Submissions Report

Forest Glen Solar Farm

March 2022

Project Number: 22-029

Figure 3-1 Updated indicative infrastructure layout for the Forest Glen Solar Farm. The Visual set-back area for R6 is located on the western boundary of the Proposal area. The Development footprint remains unchanged.

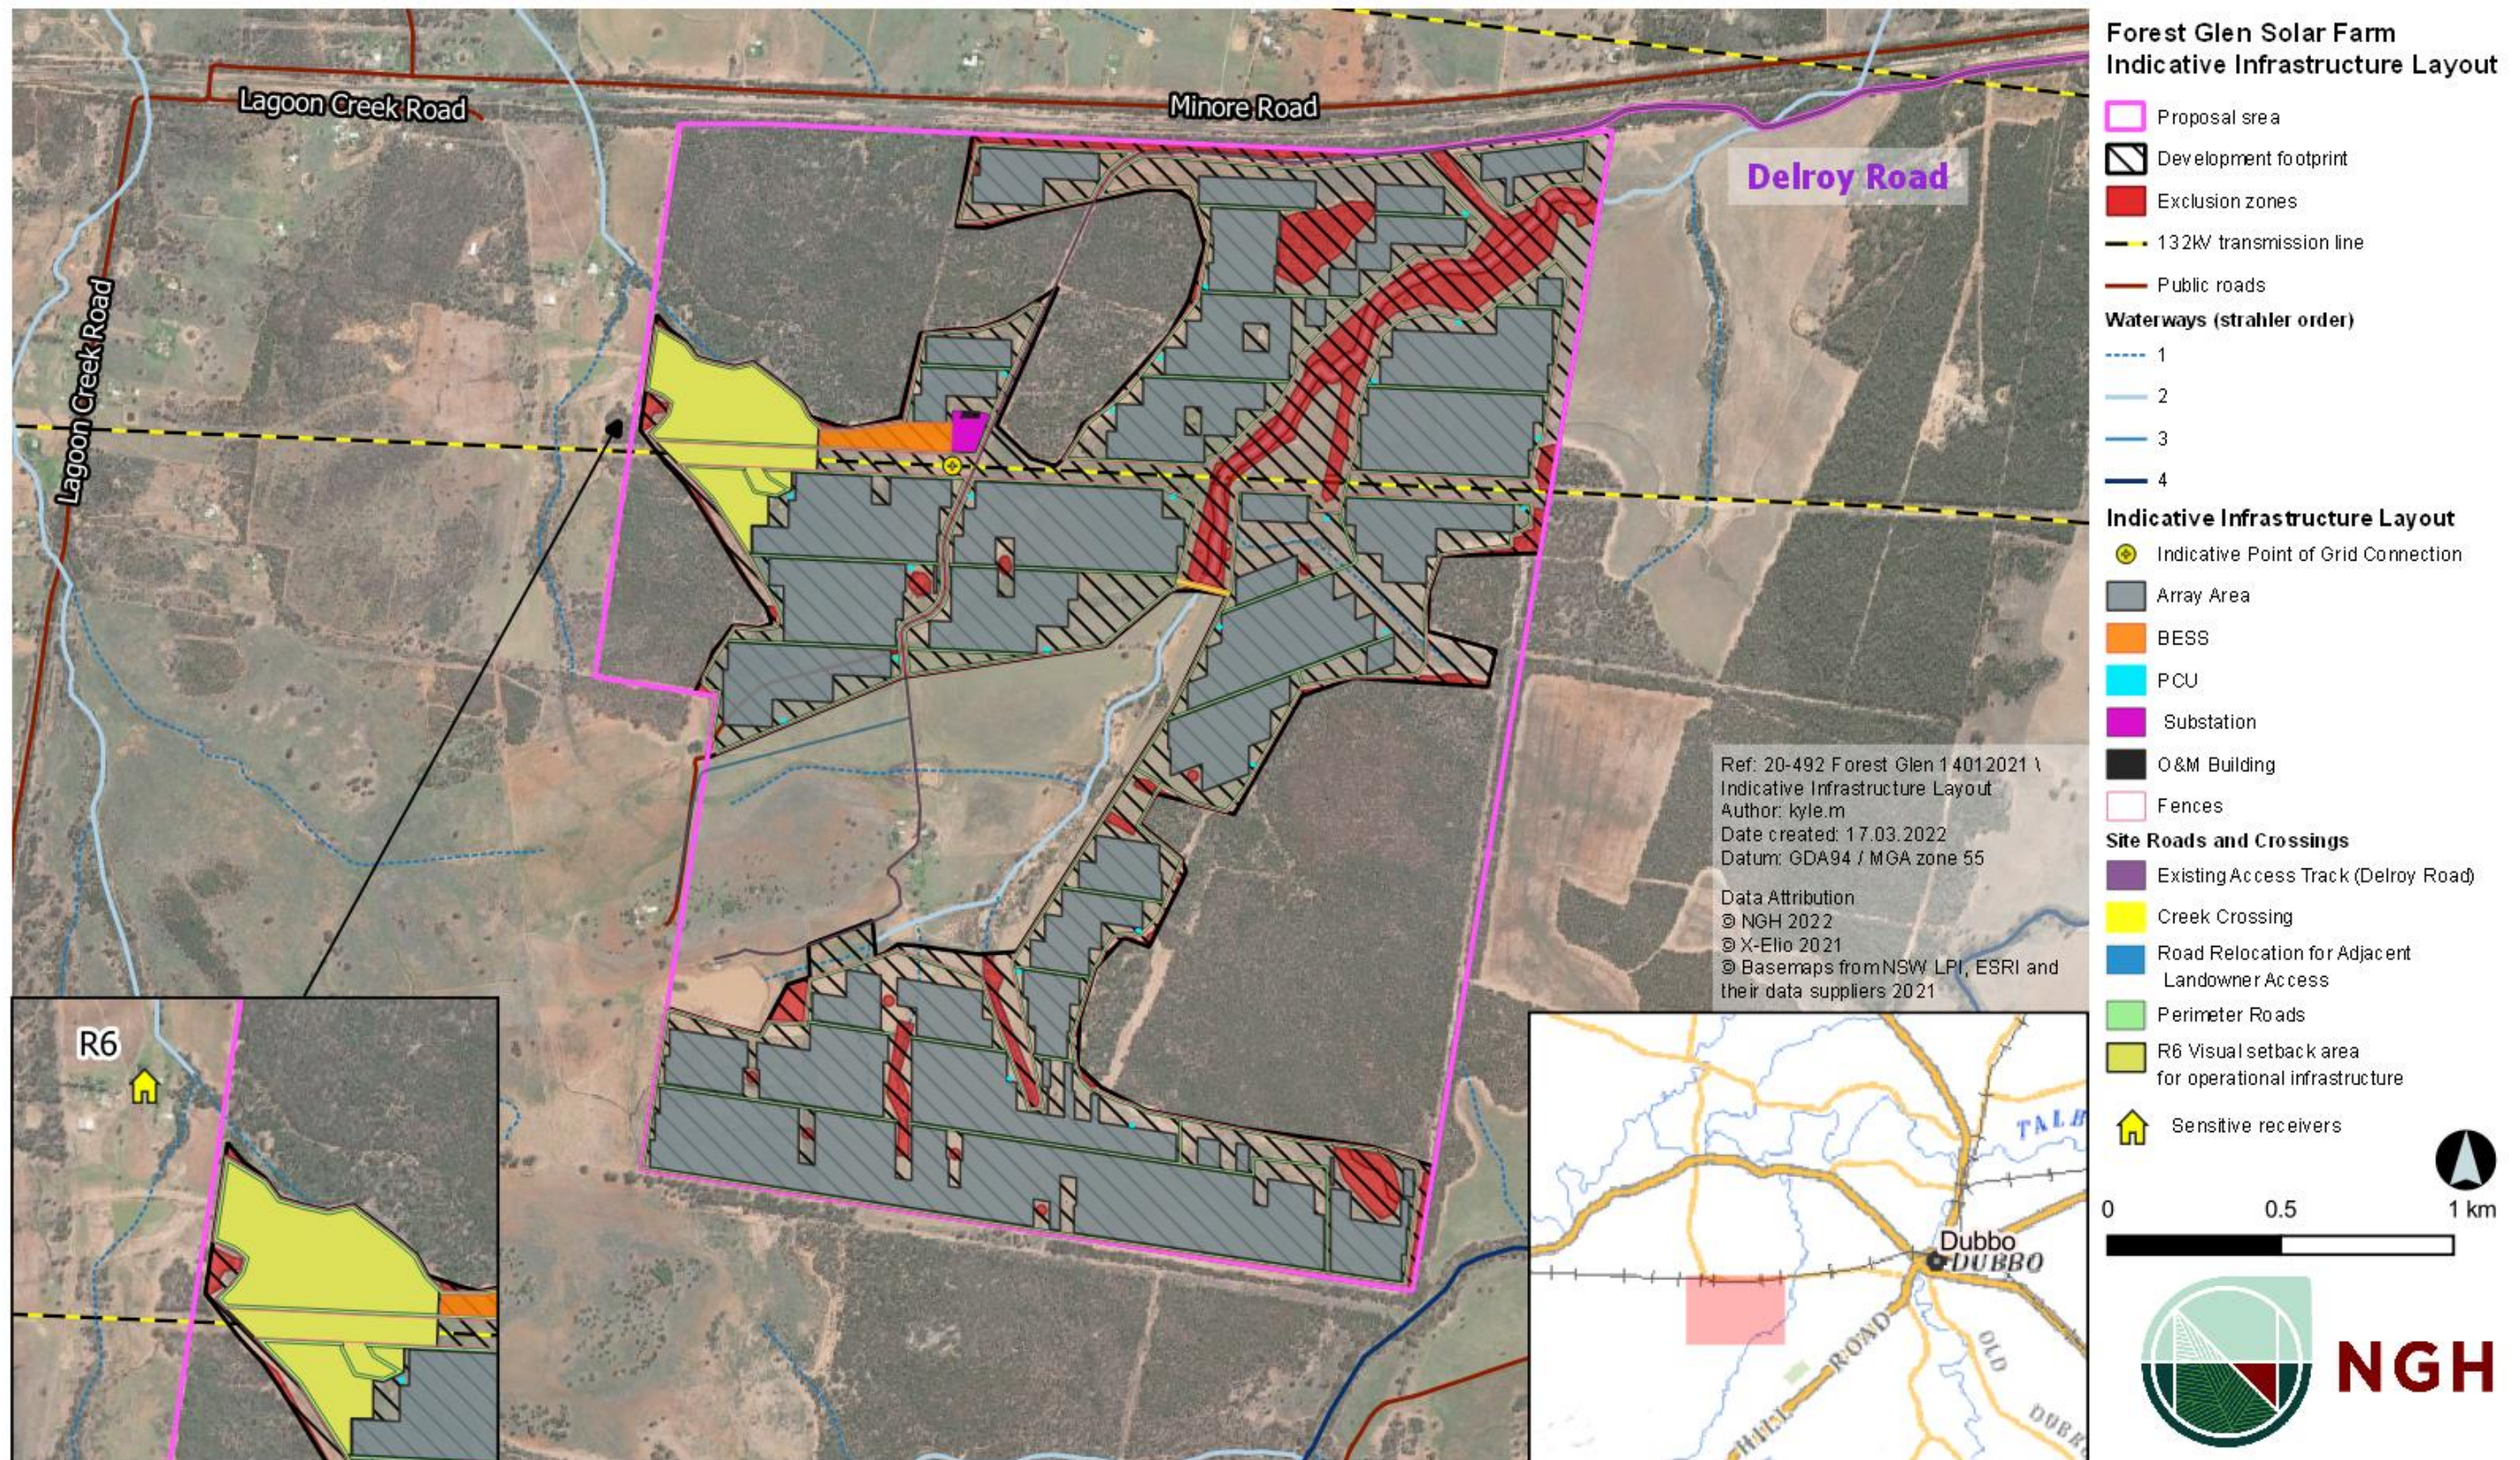
| Receiver | Date | Consultation comments |
|--|------------|--|
| Name withheld (SE-35251041; R6) | 1/03/2022 | X-Elio spoke with the receiver and her husband over a video meeting to discuss concerns they raised around the visual impact of the Proposal. Mitigation options were discussed, including vegetation screening, wire-frame analysis and the possibility to move certain parts of the plant infrastructure, including panels. |
| Name withheld (SE-35251041; R6) | 07/03/2022 | X-Elio spoke with the receiver over a video call. The discussion covered three parts of the plant in which X-Elio were able to move above ground infrastructure (including solar panels) to another area of the site in order to remove visual impact from the areas of concern identified by the receiver. Refer section 3 and Figure 3-1. |

This visual setback area is displayed as part of an updated indicative infrastructure layout for the Proposal in Figure 3-1 below and is reinforced in the updated visual impact mitigation commitments. The assessed Development footprint for which development consent is sought remains unchanged from the EIS.

| ID | Safeguards and mitigation measures | C | O | D |
|--|--|--------|---|---|
| V5 | <i>No above ground operational infrastructure would be constructed within the visual set-back area for R6 as mapped in Figure 3-1. This set back is included manage the operational visual, glare and glint impacts of the project on this receiver.</i> | C | O | |

Figure 3-2 Lots 51/ DP755094 and Lot 52/DP755094. Right of carriageway now included for Lot 51.

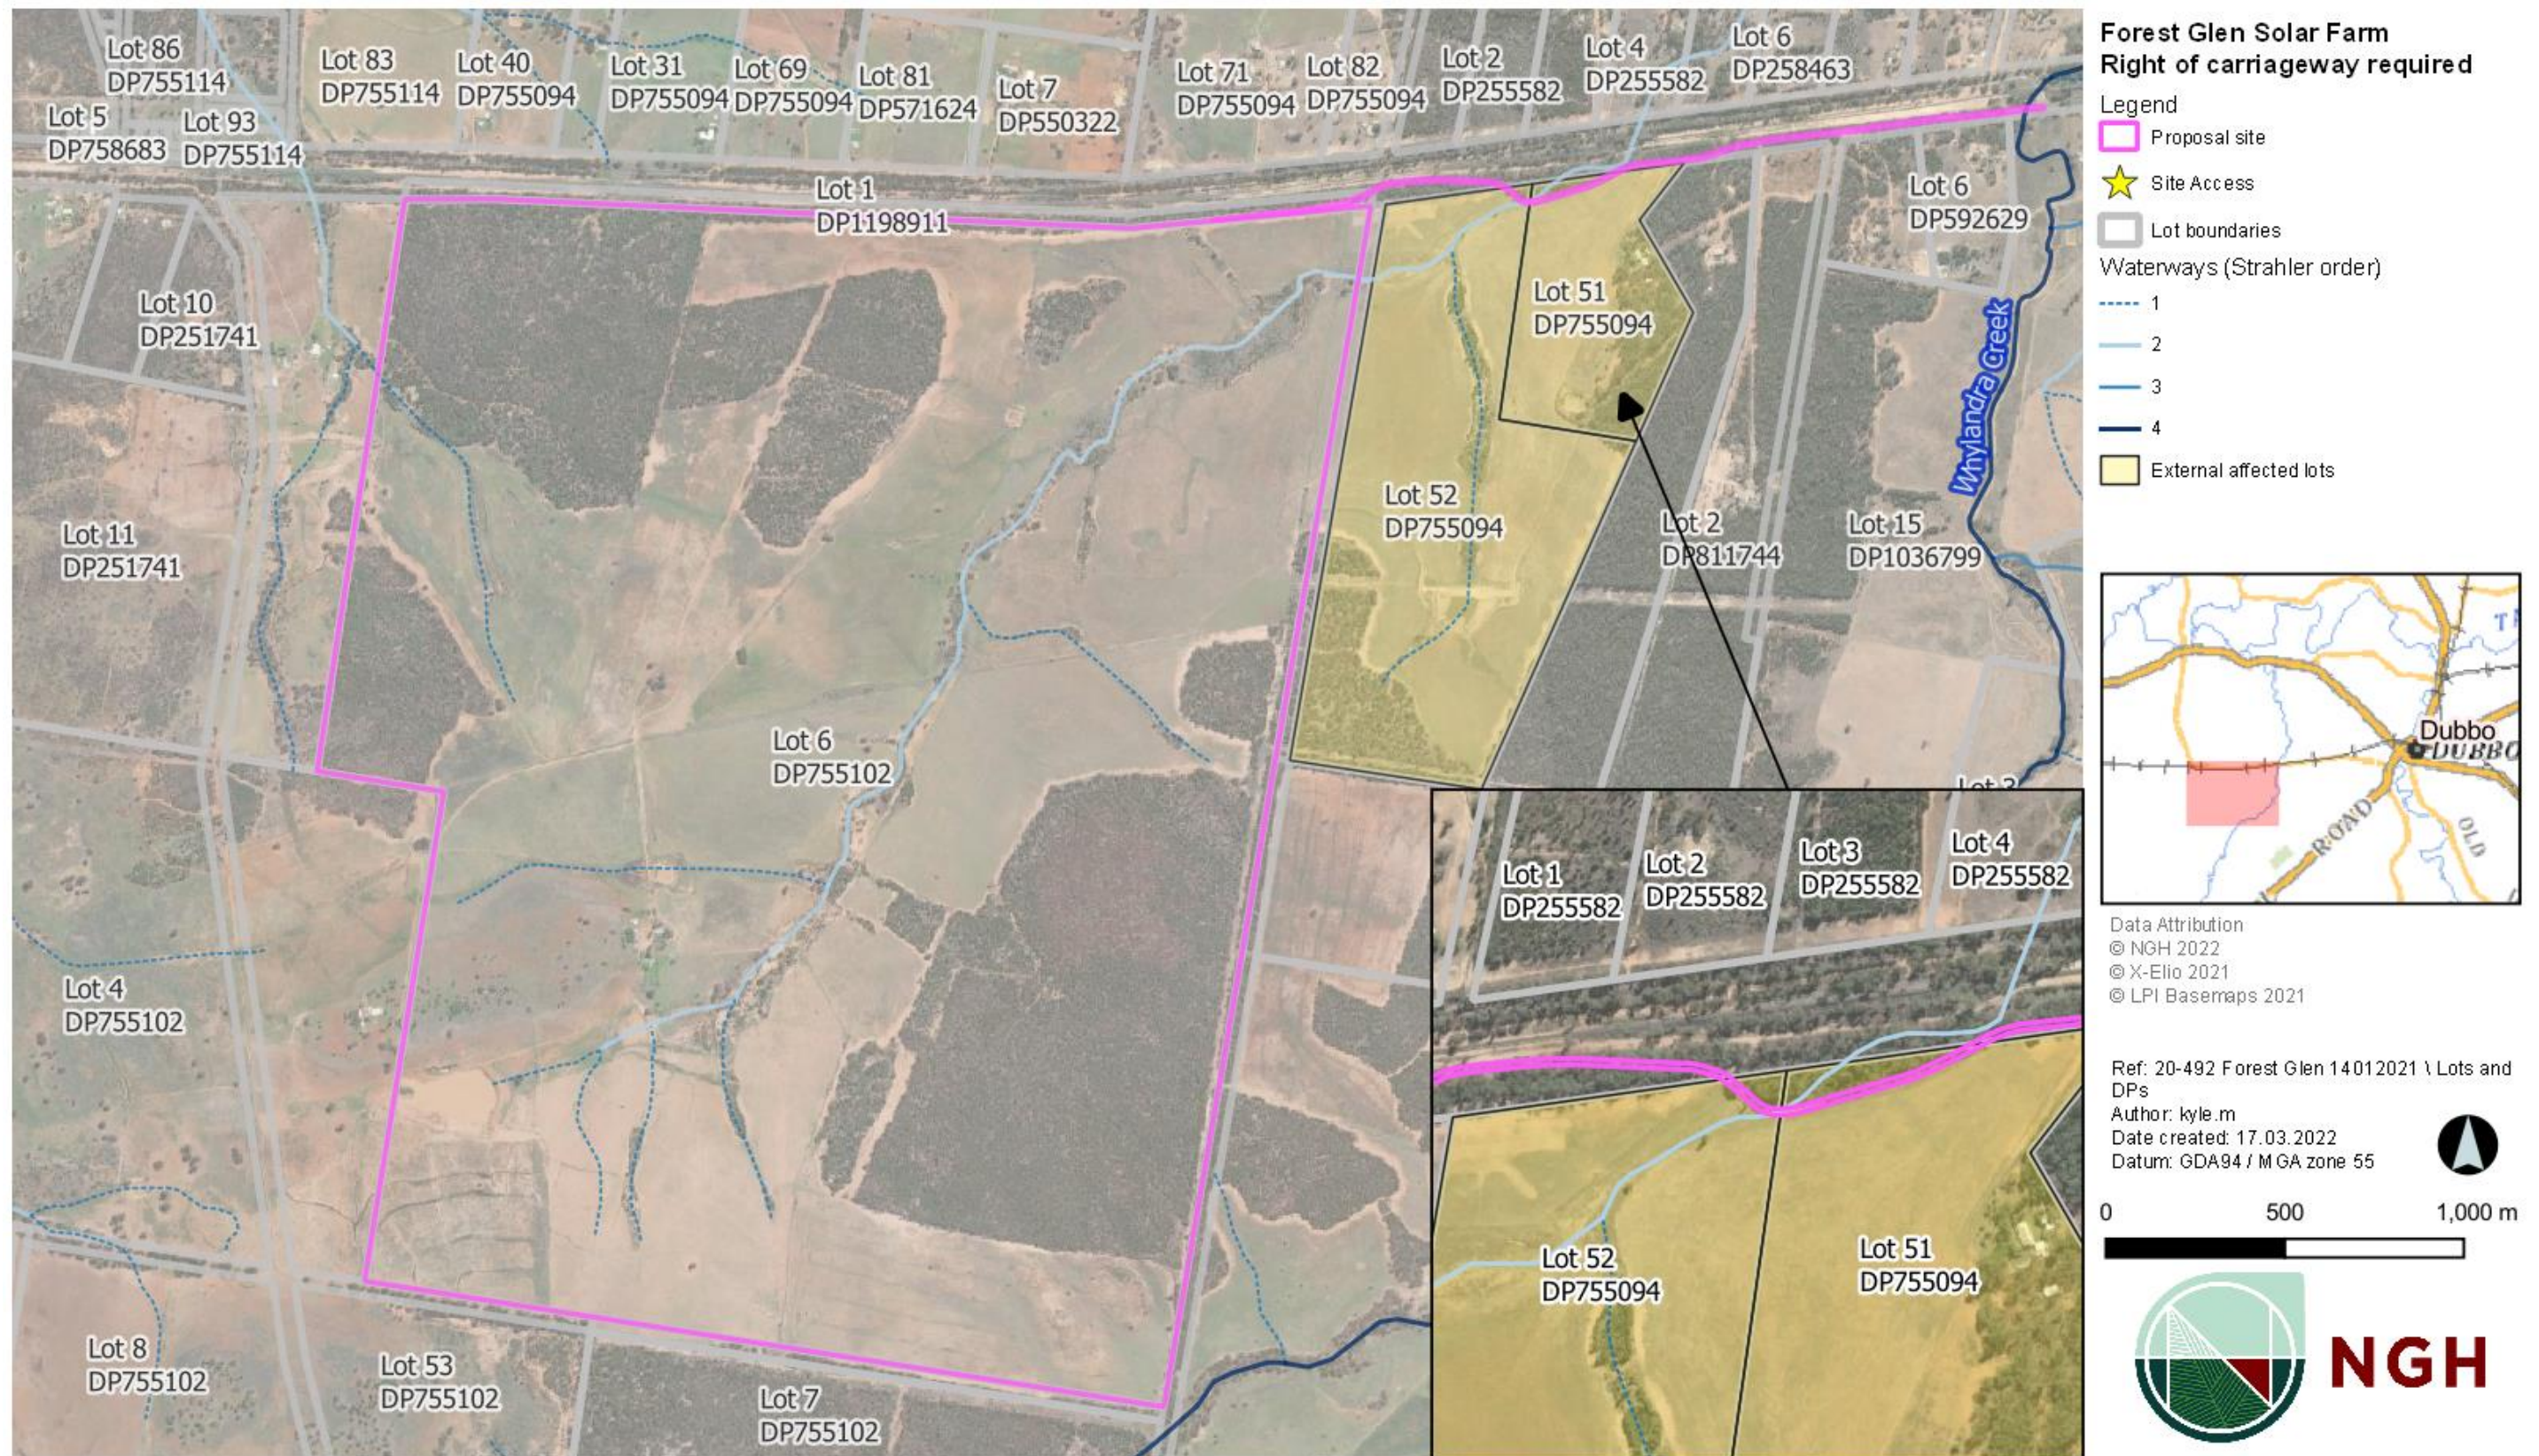
| Agency | Date | Consultation comments |
|--------|------|--|
| | | Road that deviates into private Lots 51 & 52 DP 755094 be dedicated to Council. A detailed response to the DRC submissions, including on Delroy Road, are discussed in section 4.2. |

As described in the EIS, Delroy Road would be the primary construction and operational site access road to the Proposal. Delroy Road has recently been gazetted as a local Council road. However, portions of it traverse private freehold (Lots 51/ DP755094 and Lot 52/DP755094). Refer Figure 3-2.

Following Council consultation, the Proponent has sought and obtained landowner consent to establish right of way carriageway for across these sections, to ensure legal access to the Proposal site. An additional land owner consent for right of access through the affected private lots has been provided to DPE with this Submissions Report.
